Depairiment of Water and Power

Subject: Intermountain Power Agency (IPA)

Wildcat Loadout Mining and Reclamation Plan

Enclosed are responses to your Midterm Review Task ID #3931 as well as updates to Chapters 2-8 of the Wildcat Loadout Mining and Reclamation Plan.

_	TEBRUARY 2012
מה משו זמ	DATE:
AS SHOWN	REVISION NUMBER:
WILDCAT LOADOUT SEDIMENT POND "B"	WILDCAT SEDIMENT

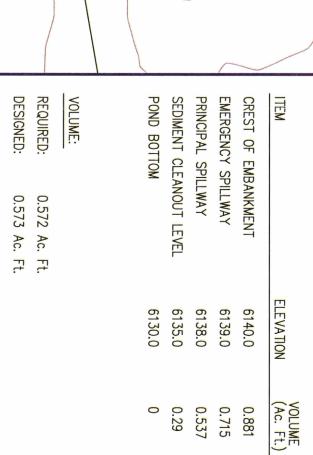
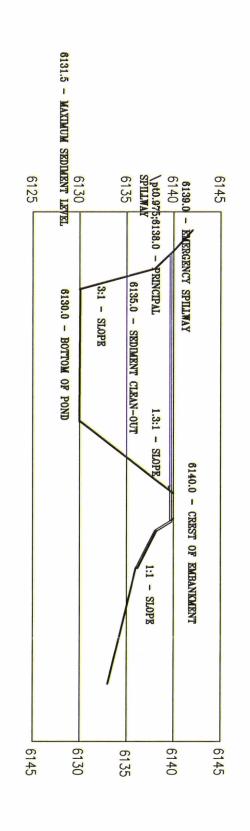
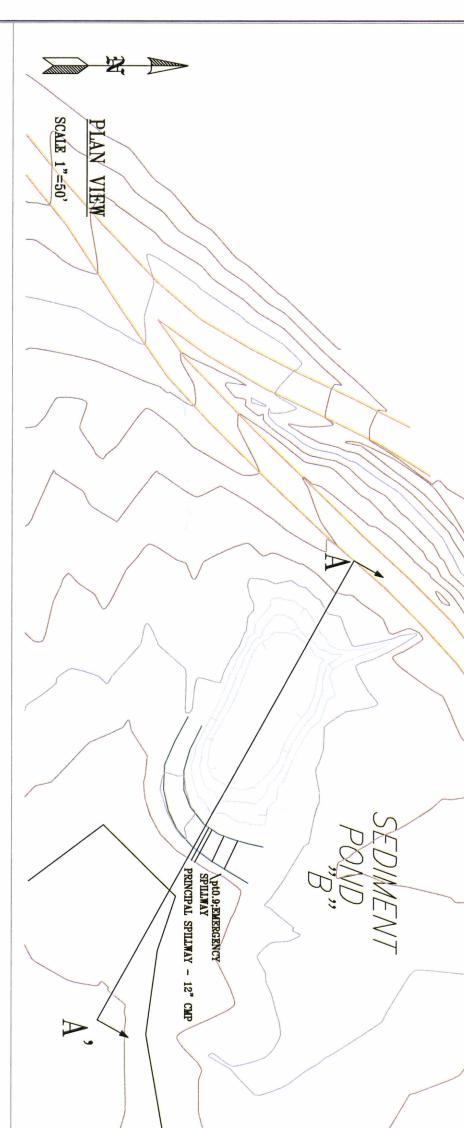
Permit			POWER AGENCY		
Mine:	WILDCAT LO			Number:	C\007\0033
Γitle:	TASK ID #39	31 MIDTER	M PERMIT REVIEW		
applicat of conte	ion. Individually	list all maps and plan, or other	to the Mining and Reclamation Plan, which is required as and drawings that are added, replaced, or removed from the information as needed to specifically locate, identify and remain and drawing number as part of the description.	plan. Includ	de changes to the table
			DESCRIPTION OF MAP, TEXT, OR MATERIA	L TO BE C	HANGED
Add	□ Replace	Remove	WILDCAT CHAPTER 2		
Add	□ Replace	Remove	WILDCAT CHAPTER 3		
Add		Remove	WILDCAT CHAPTER 4		
Add		Remove	WILDCAT CHAPTER 5		
Add	Replace	Remove	WILDCAT CHAPTER 6		
Add	Replace	Remove	WILDCAT CHAPTER 7		
Add	□ Replace	Remove	WILDCAT CHAPTER 8		
Add	Replace	Remove	BOND CALCULATION TOTAL IN APPENDIX B, PA	RT D	
Add	□ Replace	Remove	PLATE (MAPS) TABLE OF CONTENTS		
Add		Remove	PLATE 2A		
⊠ Add	Replace	Remove	PLATE 3B - "SEDIMENT POND B"
